P802.3bs Nomenclature

Pete Anslow, Ciena, P802.3bs Chief Editor

IEEE P802.3bs Task Force, 15 June 2016

Figure 118-1—CCXS and CDXS relationship to the ISO/IEC Open System Interconnection (OSI) reference model and the IEEE 802.3 Ethernet model

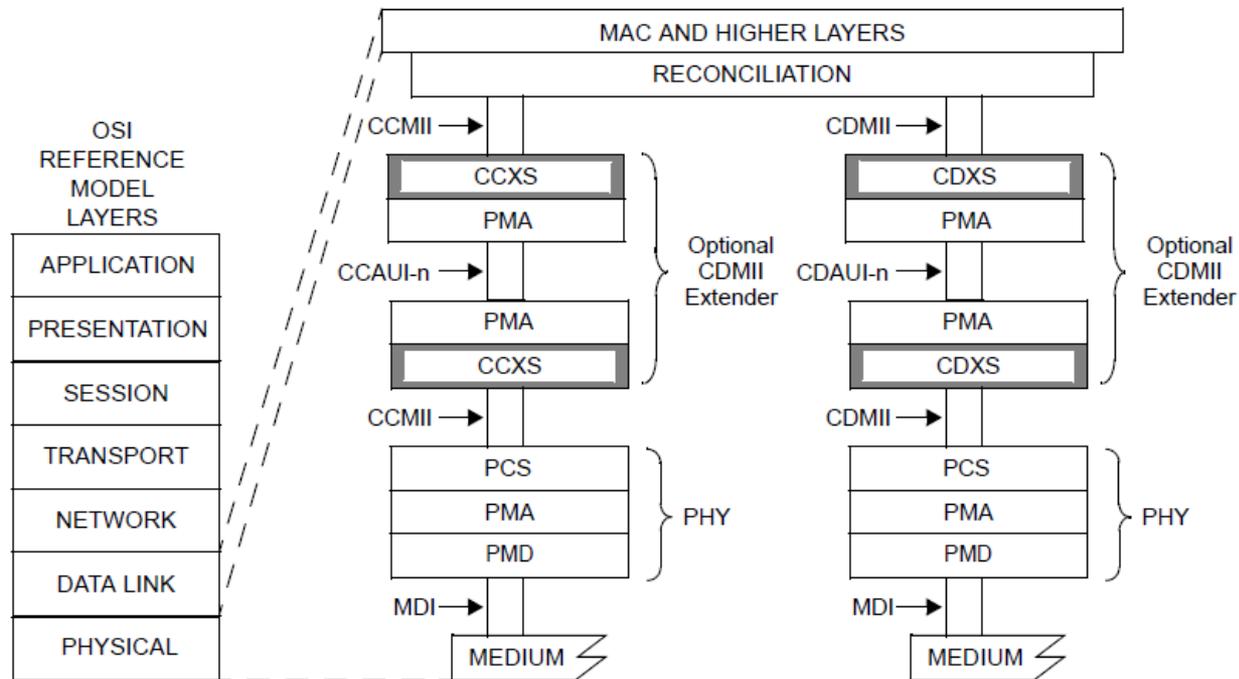
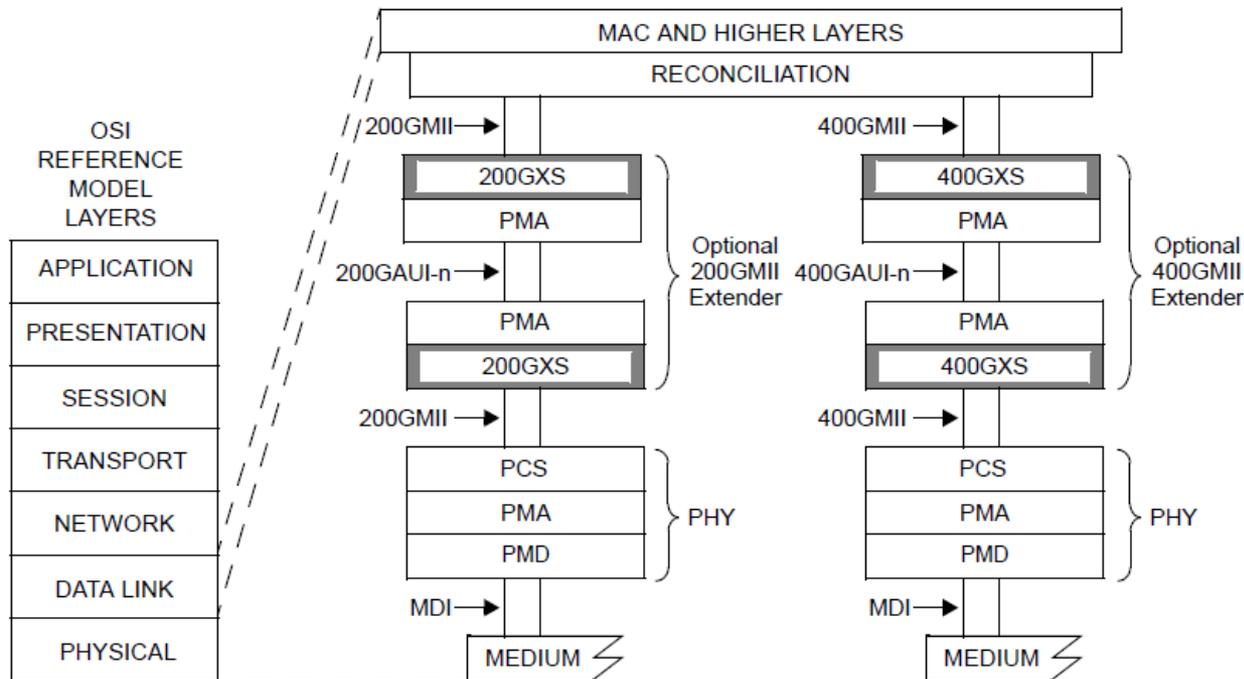
If there is agreement to change the names on page 5 it is proposed to change them to:

Figure 118-1—200GXS and 400GXS relationship to the ISO/IEC Open System Interconnection (OSI) reference model and the IEEE 802.3 Ethernet model
